CHRISTOPHER WILLIAMS ARCHITECTS LLC

ADDENDUM NO. 2

Date: November 2, 2022

Project: **SSF-2018-01 GNHWPCA COLLECTIONS MAINTENANCE FACILITY**

A5 GNHWPCA EAST SHORE WATER POLLUTION ABATEMENT FACILITY
1" = 100'-0"

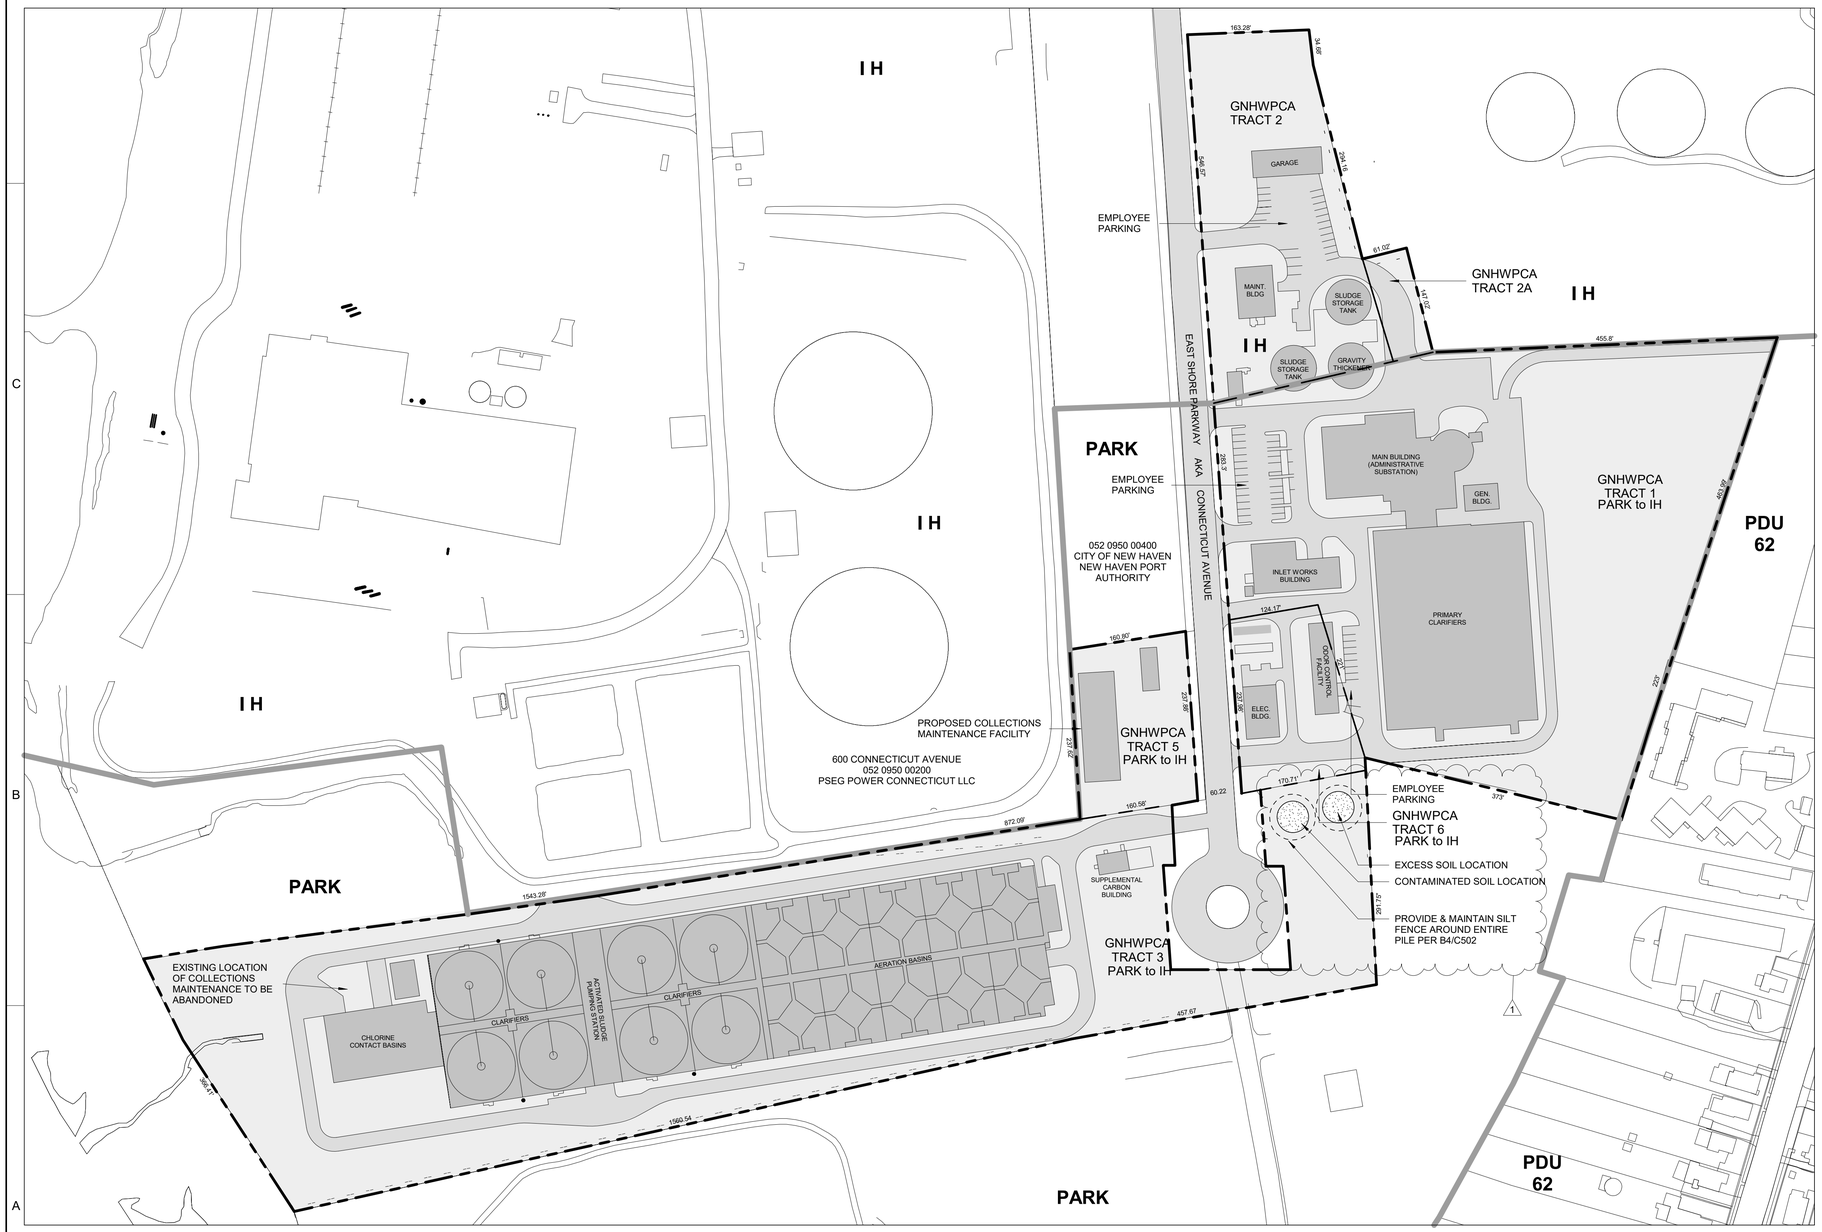
Sheet C101: ESWPAF PROPERTY PLAN
A5: EXCESS & CONTAMINATED SOIL LOCATIONS AND SILT FENCE
B2: ADDED TYP APRON & PAVING DETAIL

A5 SITE PLAN
1" = 20'-0"

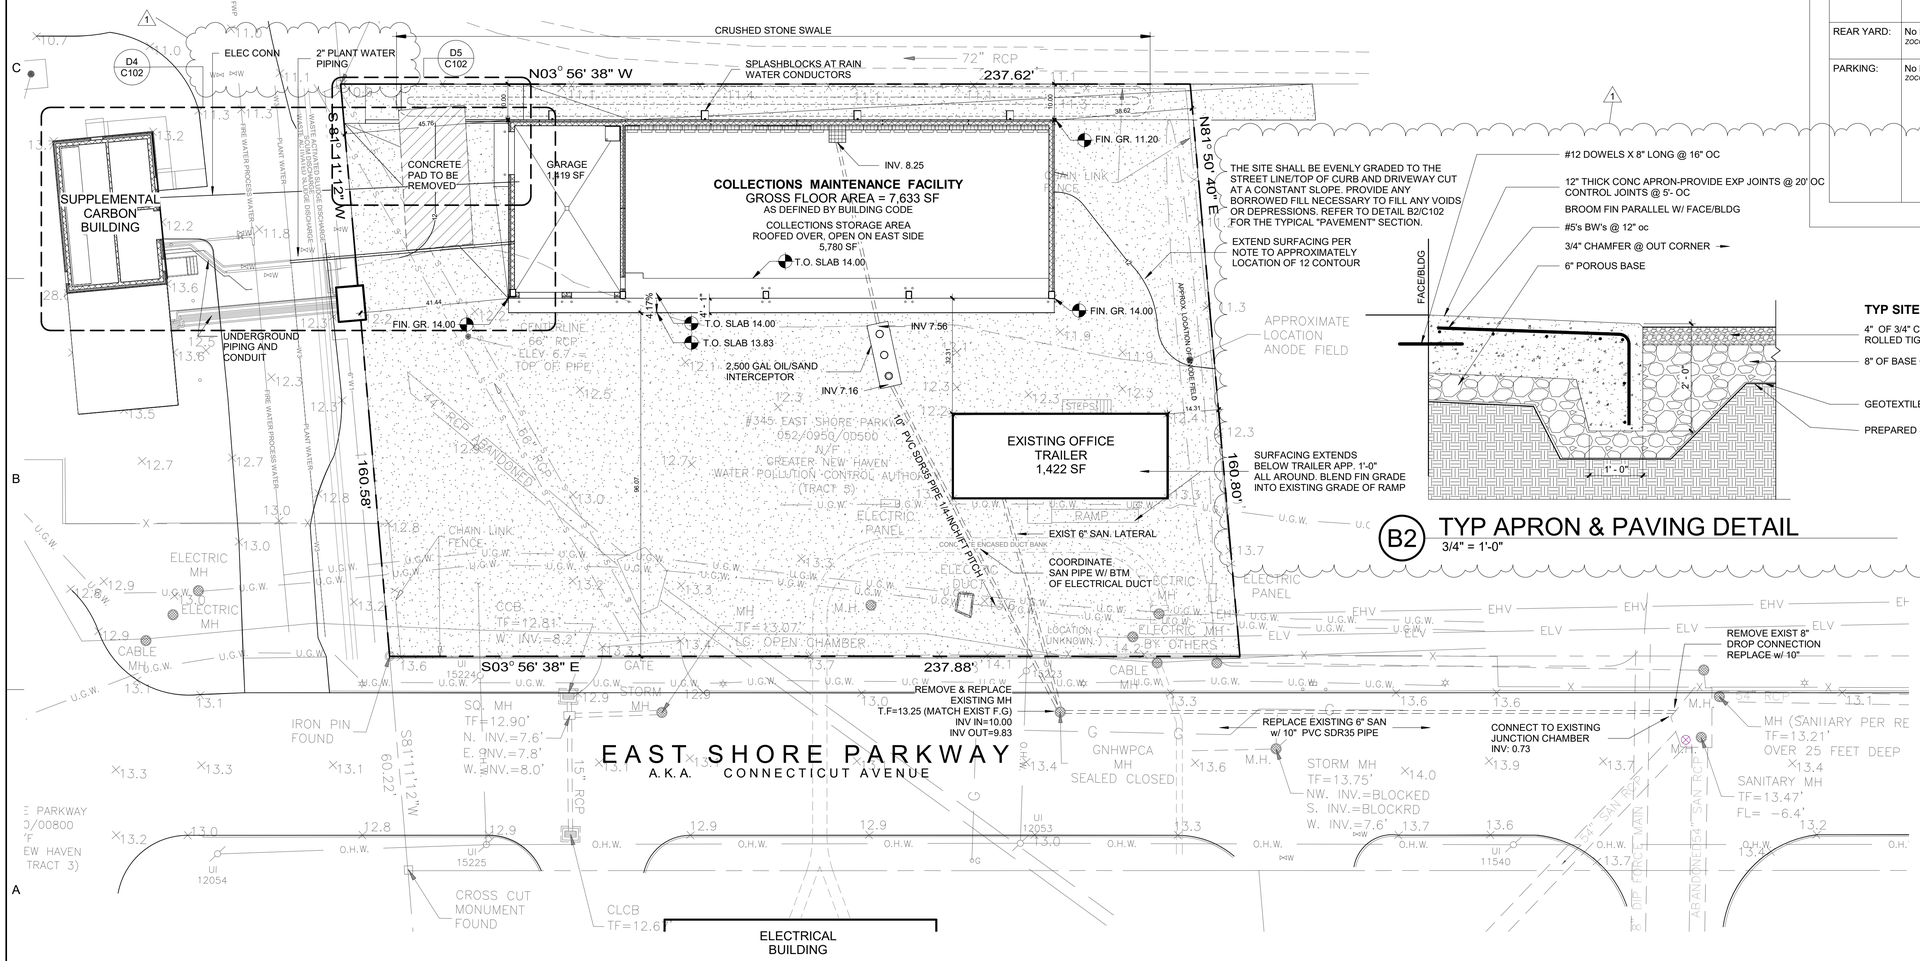
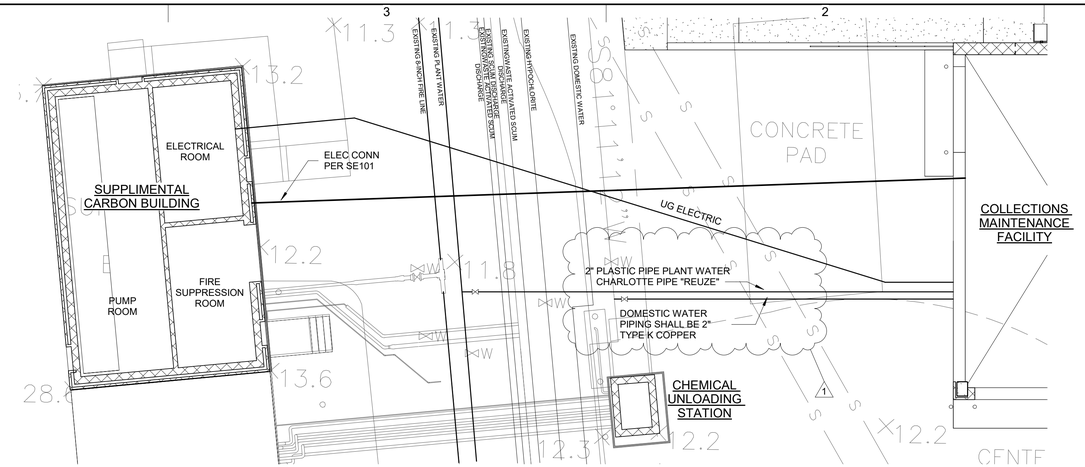
Sheet C102: SITE PLAN
A5-D4: ADDED ELEC. CONN. & PLANT WATER PIPING

C5 FLOOR PLAN AT ELEVATION +18'-0"

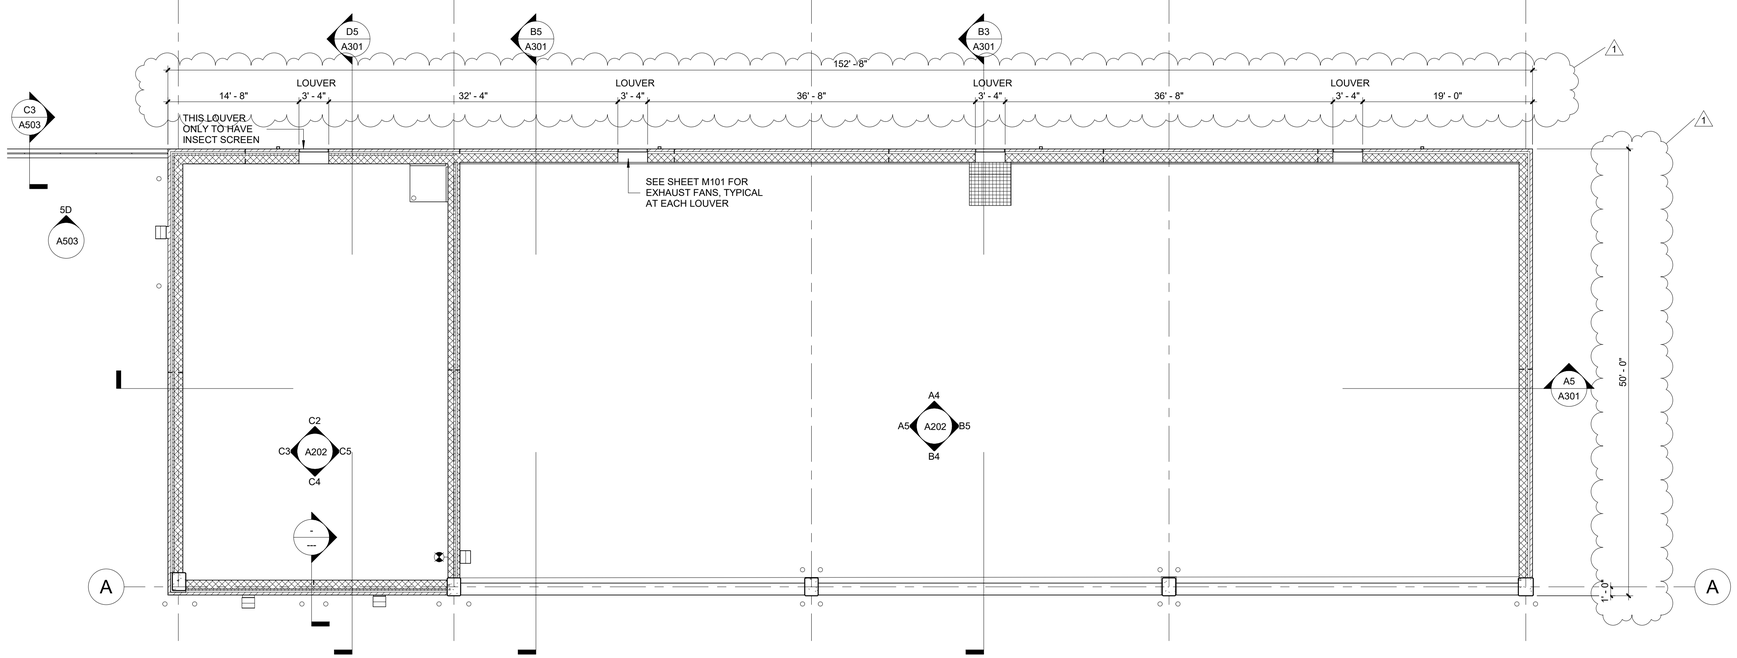
Sheet A111: FLOOR PLANS
C5: SMALLER LOUVER OPENING SIZE & UPDATED DIMENSIONS
A5: ADDED CONCRETE PAD & BOLLARD FOR ELECTRICAL PANELS AND TRANSFORMER

C5 ROOF PLAN

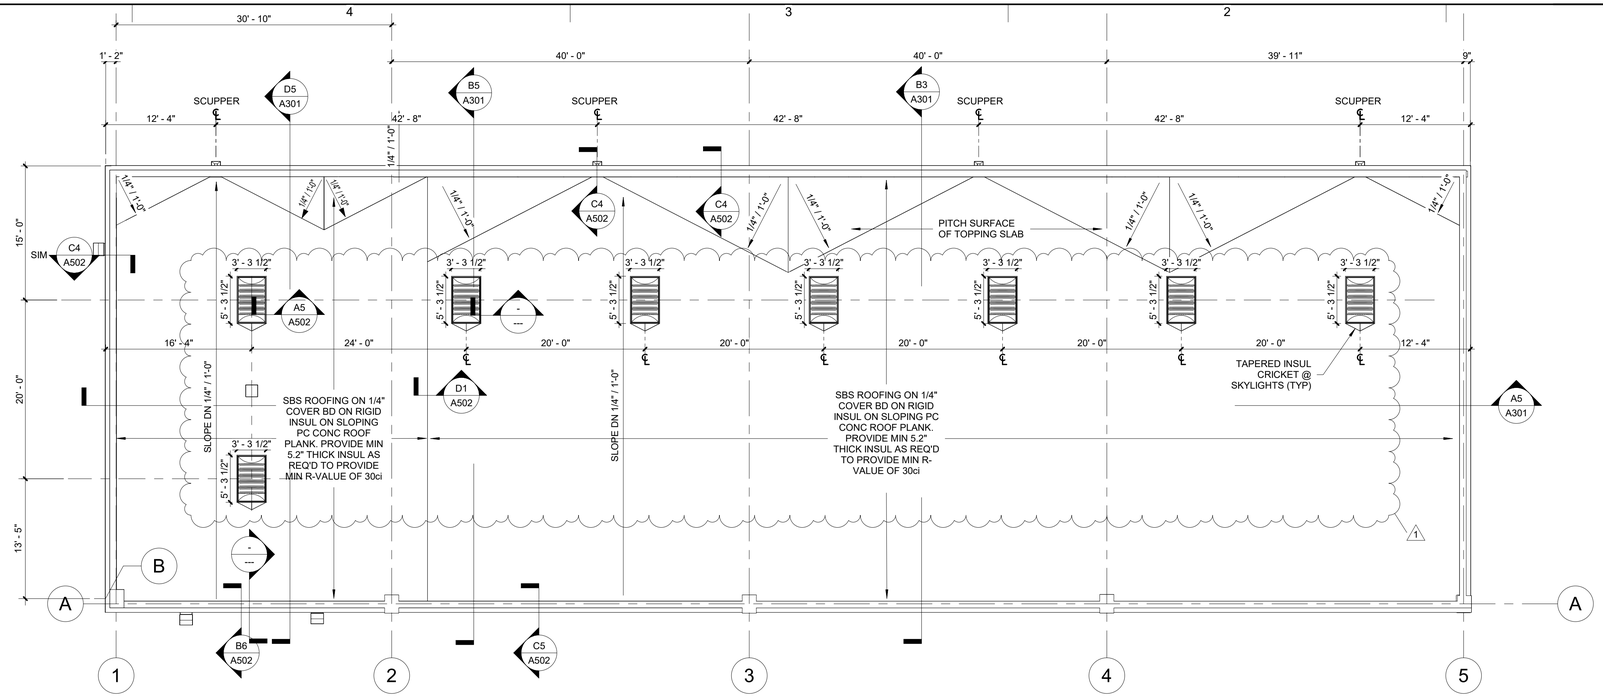
Sheet A112: REFLECTED CEILING AND ROOF PLANS
C5: ADDED TAPERED CRICKETS AT SKYLIGHTS
A5: ADDED CONDUIT NOTE

D4 WEST ELEVATION
1/8" = 1'-0"

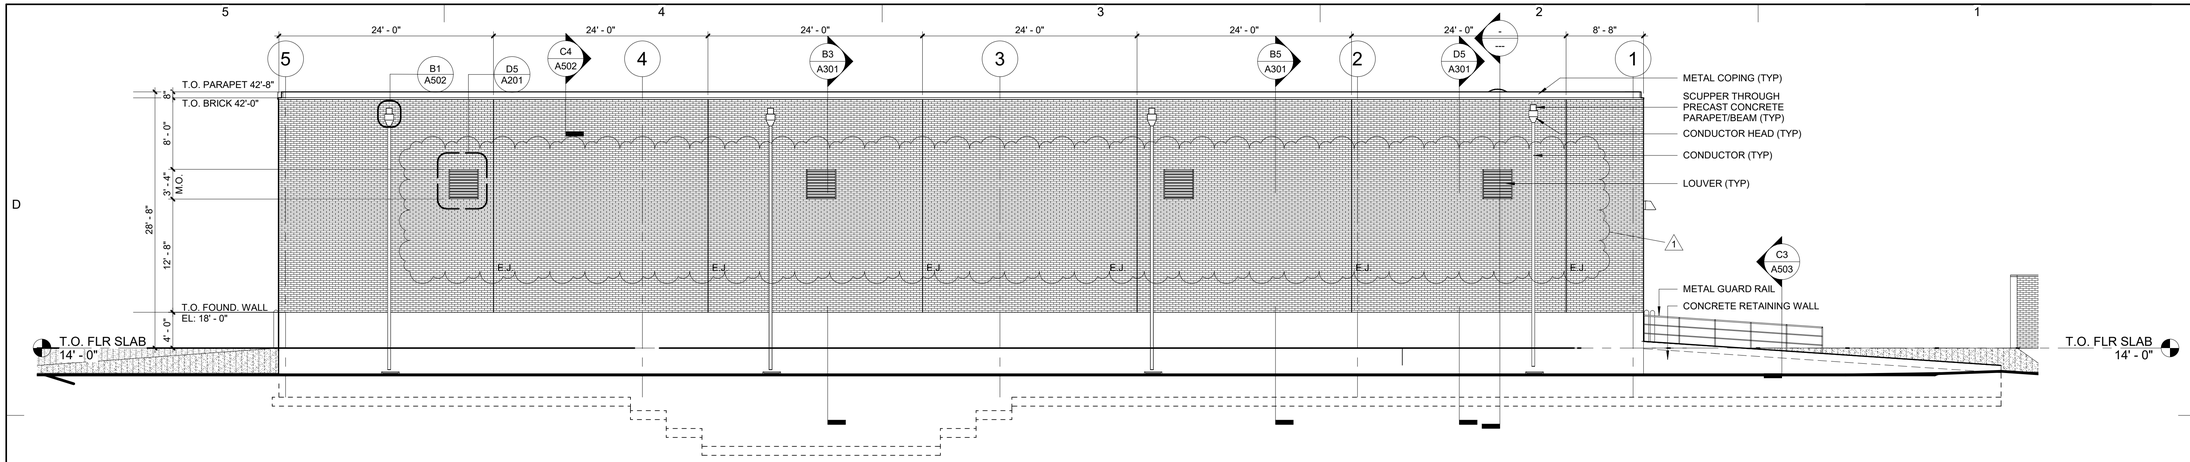
Sheet A201: EXTERIOR ELEVATIONS
D4: UPDATED LOUVER & OPENING SIZE
D5: NEW LOUVER SIZES & ADDED EXPANSION JOINTS
B4: ADDED NOTE OH COILING DR
A4-B2-B4: ADDED EXPANSION JOINTS

D5 CROSS SECTION THROUGH GARAGE

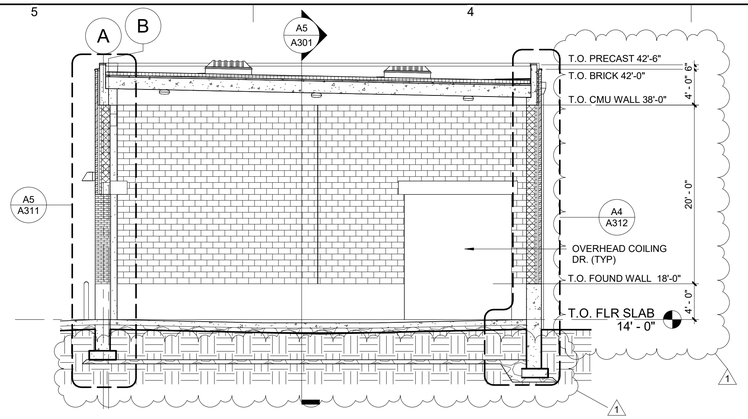
Sheet A301: BUILDING SECTIONS
D5-B3: ADDED LEVELS & NOTES
D5-B5-A5: ADDED CRUSHED STONE UNDER FOUNDATION

A5 EAST WALL SECTION thru O.H. DOOR
1/2" = 1'-0"

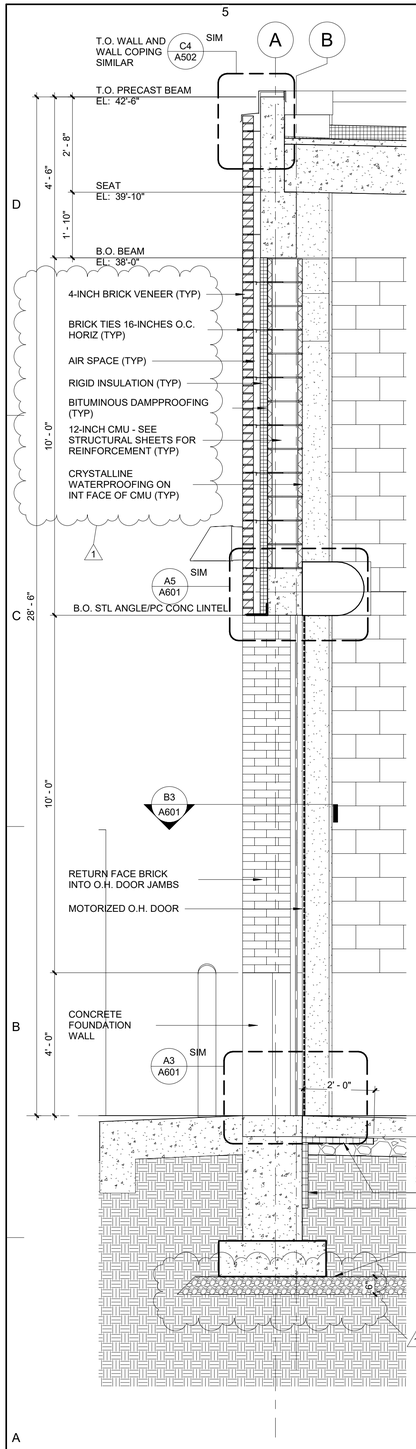
Sheet A311: WALL SECTIONS
A3: ADDED NEW DETAIL
A2: ADDED FLOOR GRATE
A5-A4-A3-A2: UPDATED NOTES
A2: ADDED ACCESS LADDER
A5-A4-A3-A2: ADDED CRUSHED STONE UNDER FOUNDATION

A4 WEST WALL Thru GARAGE
1/2" = 1'-0"

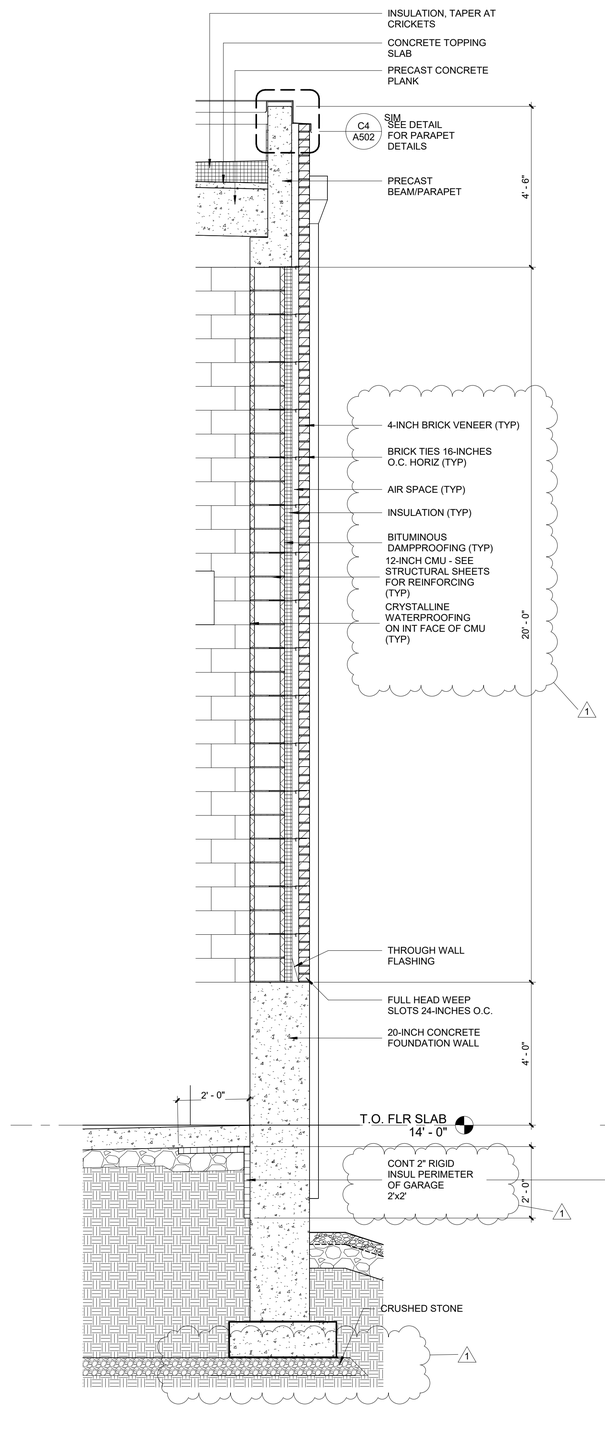
Sheet A312: WALL SECTIONS
A4-A3-A1: UPDATED NOTES
A4-A3: ADDED 2" RIGID INSULATION
A4-A3-A1: ADDED CRUSHED STONE UNDER FOUNDATION

D5 LOUVER HEAD
3" = 1'-0"

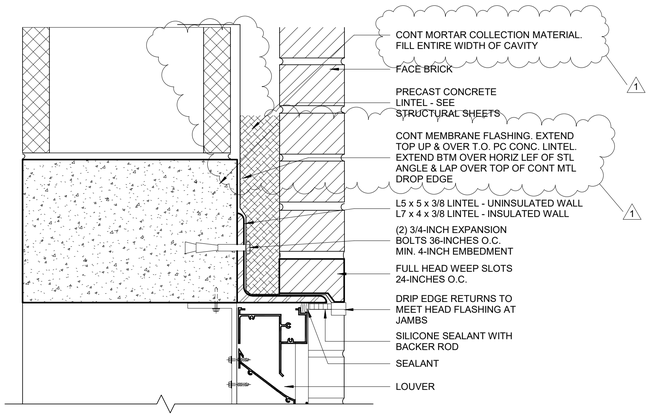
Sheet A501: OPENING DETAILS
C2-B2-A2: EXPANSION JOINT DETAILS
A4: ADDED FLASHING COMPONENT
B4: UPDATED SILL NOTE
D5: ADDED MORTAR COLLECTION
D5: UPDATED FLASHING DETAIL
B5: UPDATED MASONRY TIES
C3-B3-A3: MOVED DETAILS TO SHEET A601

C4 WEST PARAPET SECTION
3" = 1'-0"

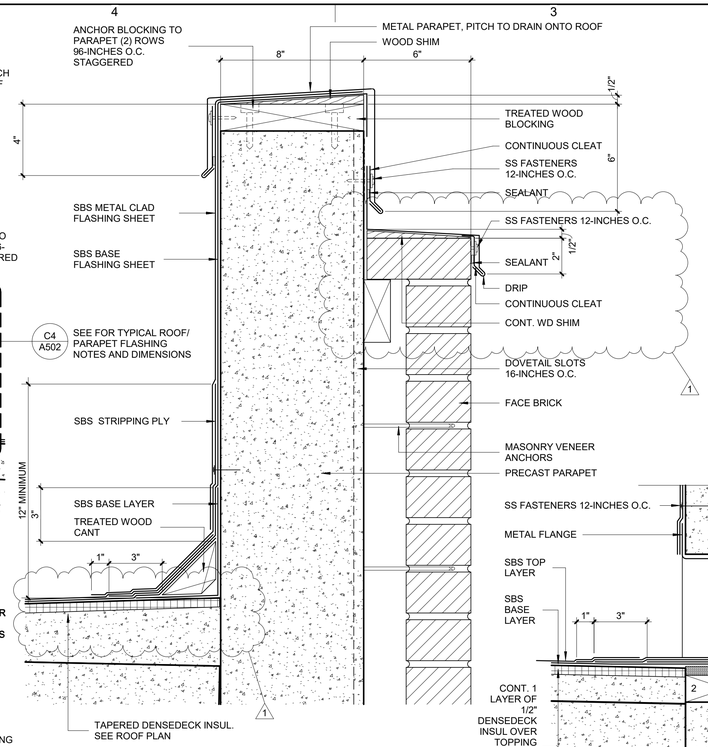
D1: UPDATED ROOF STEP DETAIL
C4: ADDED BLOCKING & SHIM
C4-B3: ADDED INSULATION
A4: REMOVED DUPLICATE DETAIL

C3 RETAINING WALL
1/2" = 1'-0"

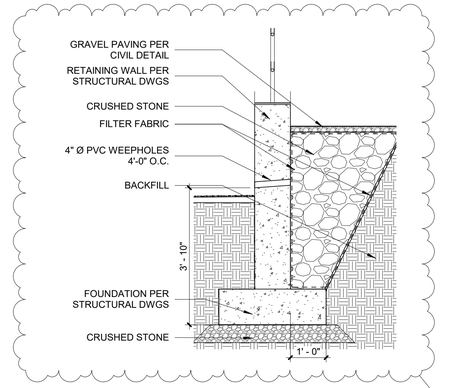
Sheet A503: DETAILS
A5: UPDATED BOLLARD FOOTING DEPTH
A4: BOTTOM OF MASONRY CAVITY DETAIL
A2: UPDATED DETAIL
C3: ADDED NEW DETAIL OF RETAINING WALL
B2: UPDATED STEEL ANGLE

B3 O.H. DOOR JAMB
3" = 1'-0"

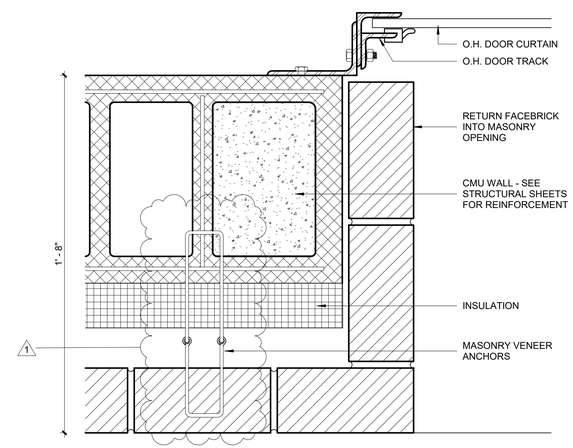
Sheet A601: SCHEDULES
A5: UPDATED INSULATION, MORTAR COLLECTION & WEEPS
B3: UPDATED MASONRY ANCHORS
B2: UPDATED DOOR JAMB DETAIL
DOOR SCHEDULE: UPDATED DETAIL LOCATION
